Report: TAB Report
Function: Test, Adjust, & Balance
Date: 08/27/2025
Completed By: National TAB

PROJECT
08-25-25 CAVA DANBURY, CT

Project: 08-25-25 CAVA DANBURY, CT

Asset: RTU1

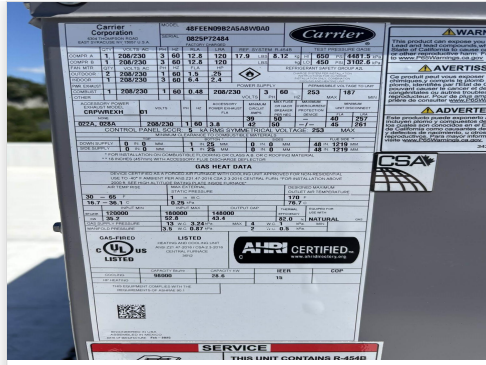
Notes:
ACPSP does not have dampers. Not able to adjust diffusers. Only balanced total airflow on entire unit.

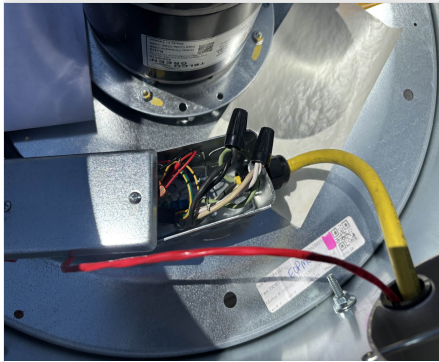
Issue Name : HD1: Small Penetration in Canopy
Description : Small penetration in hood canopy high up on right side. Recommend repairing according to manufacture directions.
Created By : National TAB **Assigned To :** National TAB - Dan Hertenstein
Status : Open
Priority : Low **Asset Tag :**
Originated Date : 08/25/2025 - Ryan Smith - National TAB

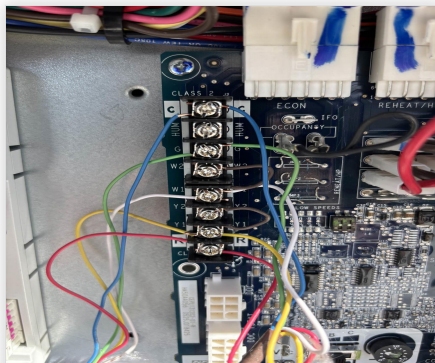
Issue Name : RTU1, RTU2: Controller Wiring Incorrect
Description : Controllers in RTUs are wired incorrectly. Y1 is jumped to Y2 and W1 is jumped to W2. Also, thermostats do not send occupancy signal to correct terminal on board, only toggling fan mode instead.
Created By : National TAB **Assigned To :** National TAB - Dan Hertenstein
Status : Open
Priority : Low **Asset Tag :**
Originated Date : 08/27/2025 - Ryan Smith - National TAB

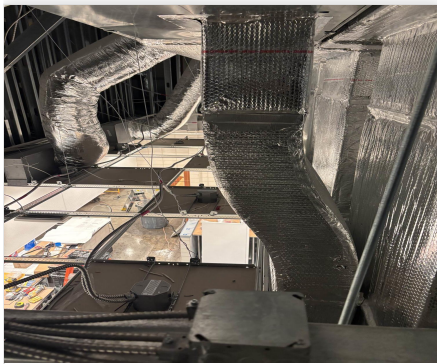
Issue Name : RTU1, RTU2: Power Exhaust Not Operational
Description : Power exhaust on both RTUs is not operational. Recommend servicing.
Created By : National TAB **Assigned To :** National TAB - Dan Hertenstein
Status : Open
Priority : Low **Asset Tag :**
Originated Date : 08/27/2025 - Ryan Smith - National TAB
